CM/CB
16334
15 December 2016

**SSD 7745 RESPONSE TO SUBMISSIONS
SITE 18, DAWN FRASER AVENUE, SYDNEY OLYMPIC PARK**

Figure 1 – Extract from the Draft Plan – Figure 5.16 Central Sports Precinct Land Uses Plan
Source: Sydney Olympic Park Master Plan 2030 (2016 Review)

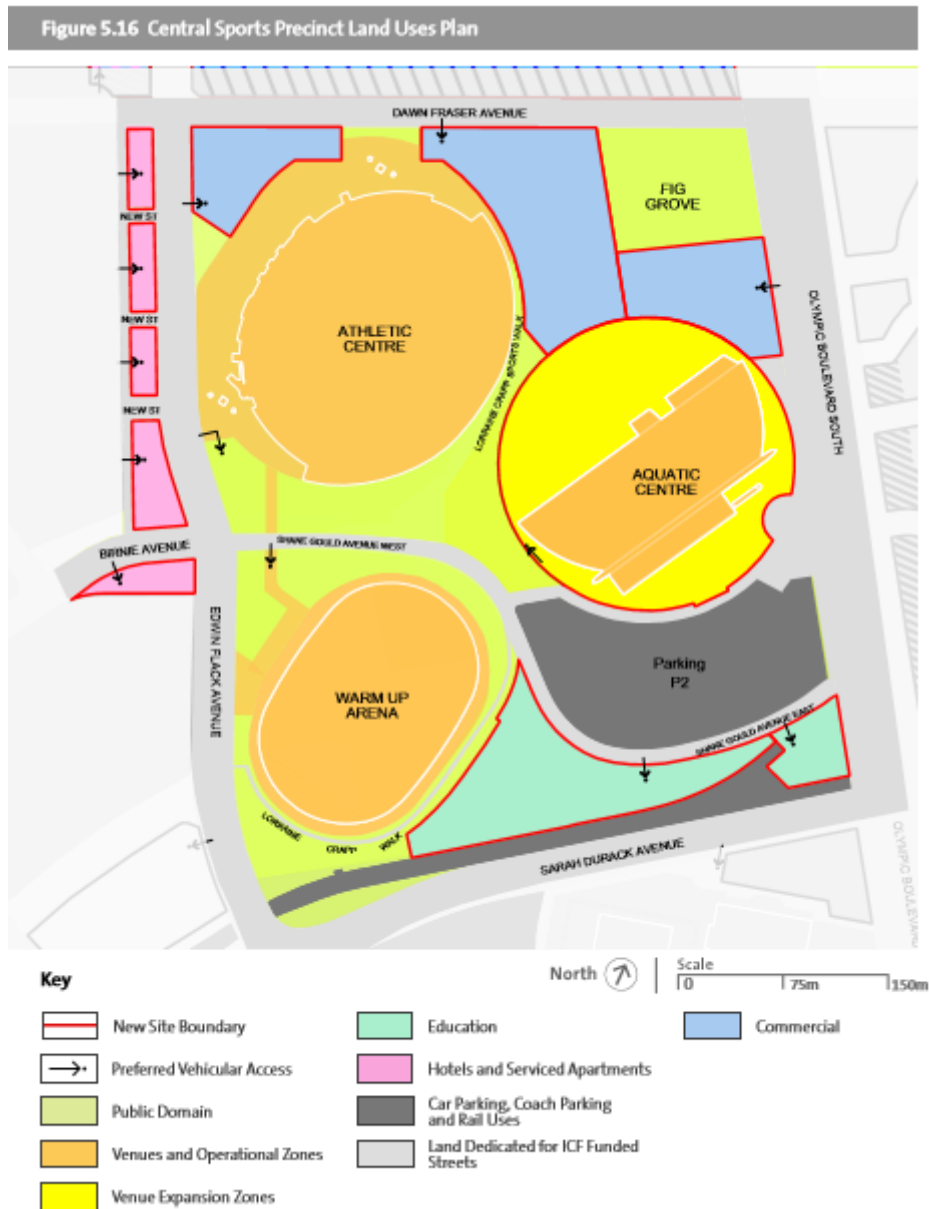
Provide further justification of the consistency of the proposed land use with the land use controls in Section 4.5 of the Draft Sydney Olympic Park Master Plan 2030 – 2016 Review (the Draft Plan).

Under the Draft Plan, land uses are to comply with Figure 5.16 Central Sports Precinct Land Uses Plan, as shown in **Figure 1** below.

The site is identified as falling within the Commercial' land use zone within the Central Sports Precinct and the permitted land uses within the Commercial zone (as set out in Section 4.5 of the Draft Plan) are as follows:

The proposed land uses are therefore consistent with the permissible land uses set out in Section 4.5 of the Draft Plan.
